DARGUES REEF GOLD PROJECT

Section 75W Modification (MP_10_0054 Mod 2)

Figure 2: Approved Project Layout and Local Context

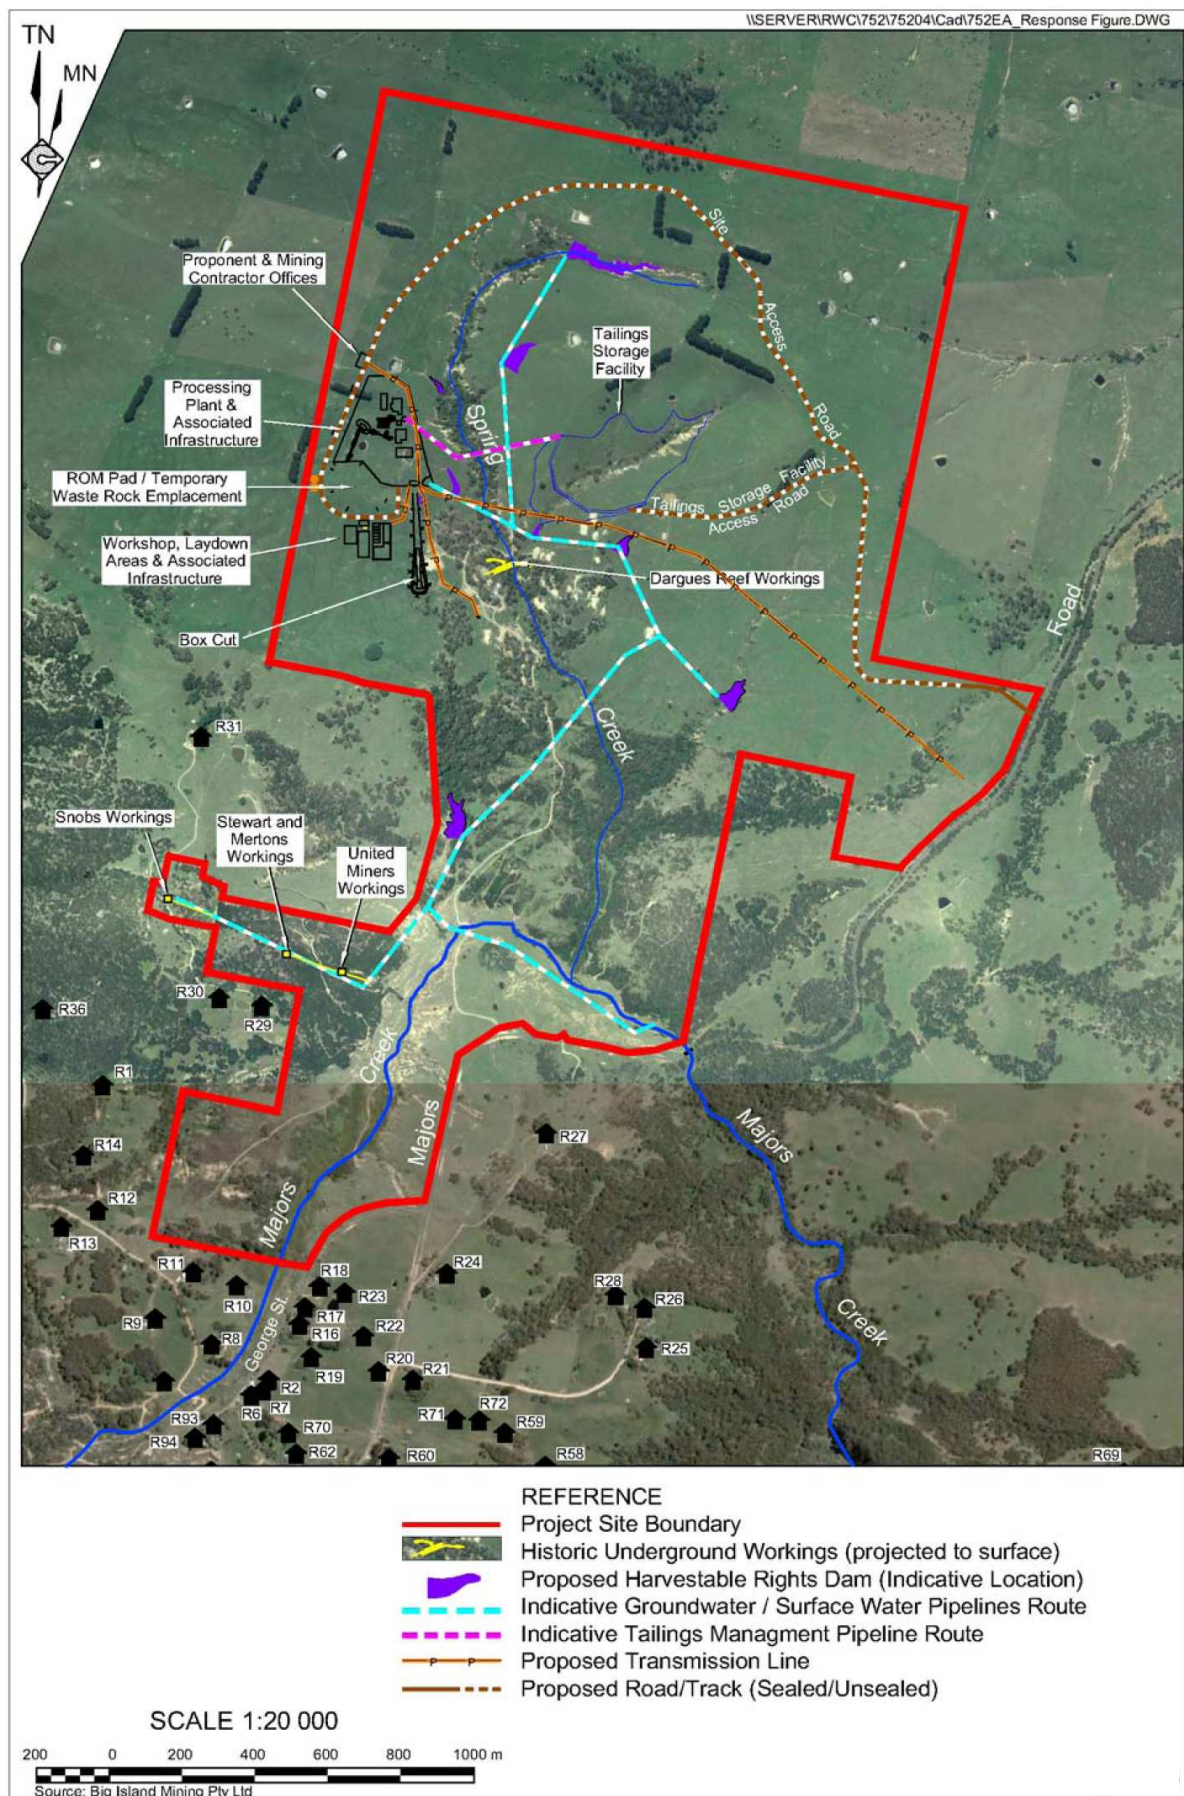
The EPA raised concerns about the lack of calibration of the revised noise modelling with noise monitoring from the site. However, the Department notes that the noise monitoring conducted to date has been during construction, and does not provide a sound basis to calibrate the noise model at this stage. Furthermore, the proposed modification is unlikely to appreciably alter the noise envelope of the project, and is likely to reduce noise impacts as some of the components of the project would be located further away from the residents (refer to Figure 2).

Figure 3: Comparison of Approved and Proposed Project Layout

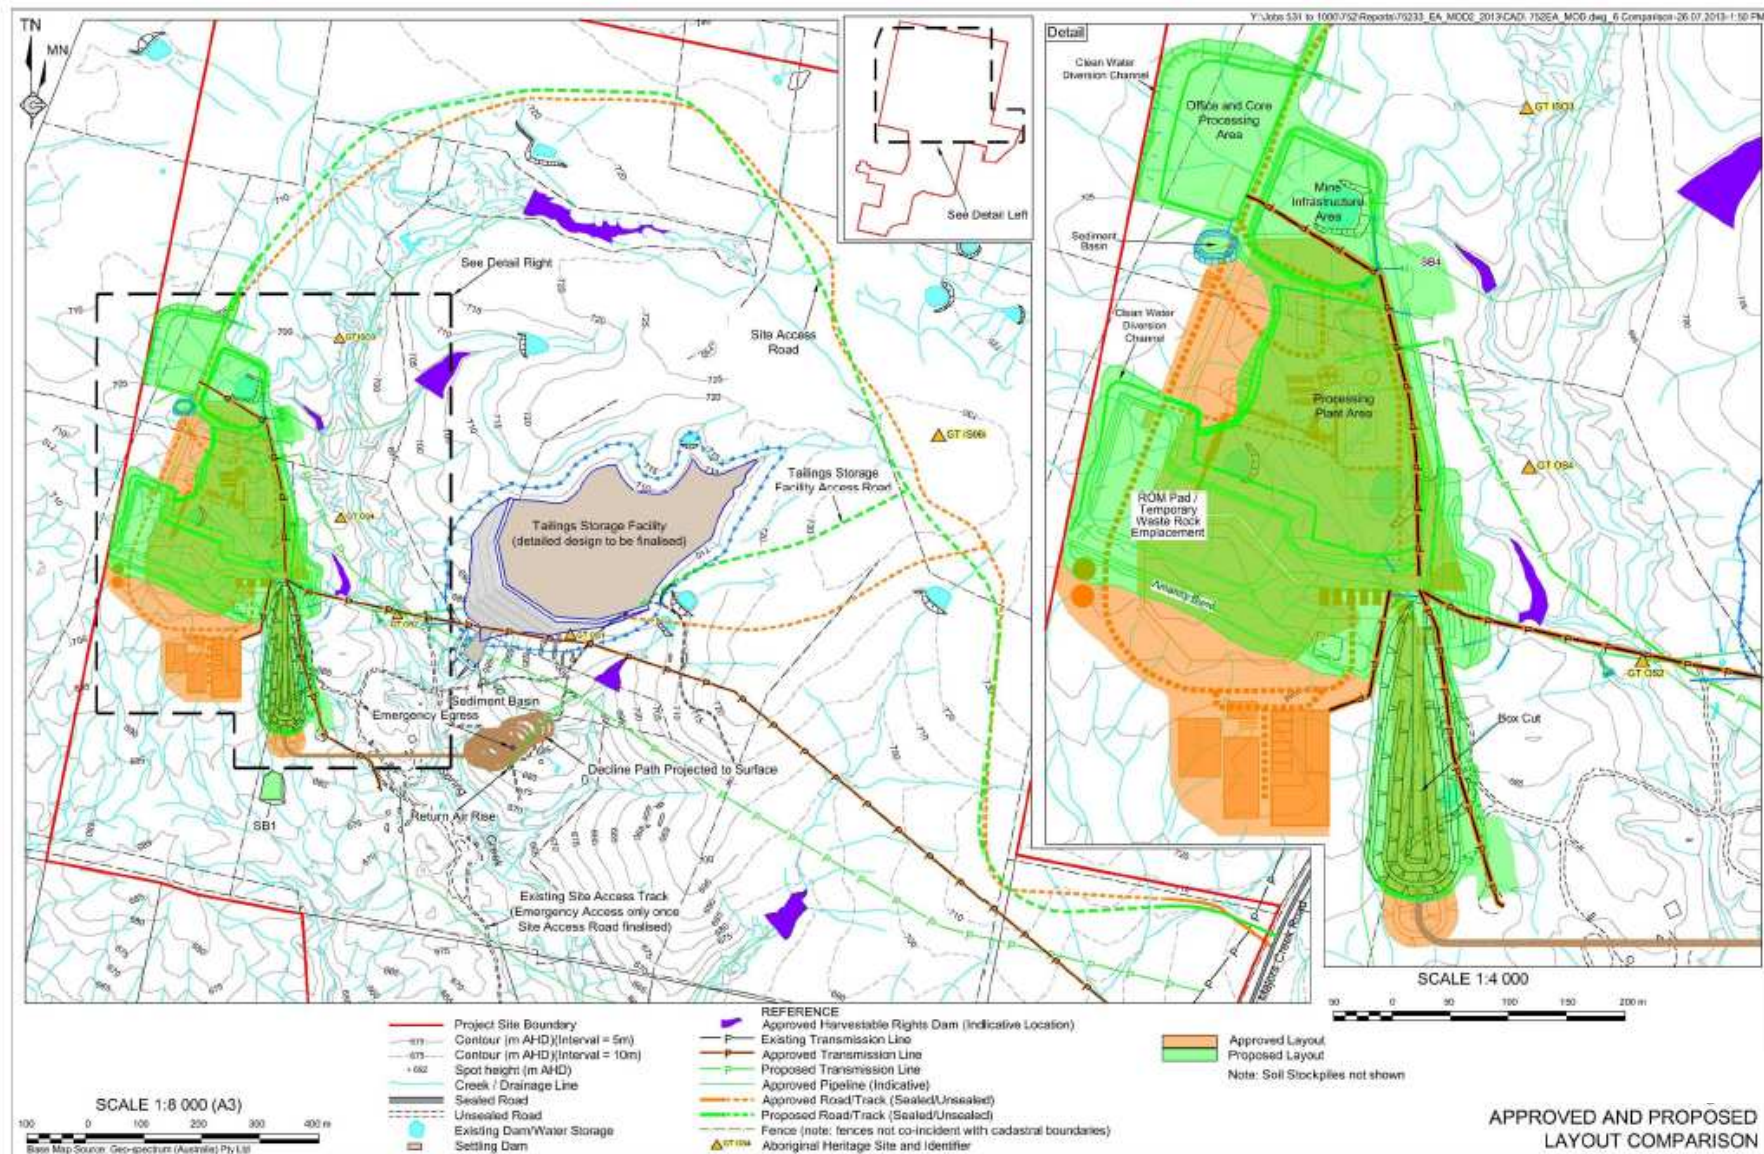
The existing layout and surrounds is shown in Figure 2, and a comparison of the approved and proposed layout is shown in Figure 3. It can be seen from Figure 3 that the majority of the revised layout would be located within the originally approved footprint, but that there would be some areas of additional disturbance.

The noise environment in the area is typical of a quiet rural area with relatively low background noise, especially at night. There are no residential receivers immediately adjacent to the site, and the original assessment predicted that there would be no exceedances of the applicable noise criteria. The majority of the receivers live more than 2 km south of the site in the village of Majors Creek, although there is one residence approximately 1 km to the south (see Figure 3).
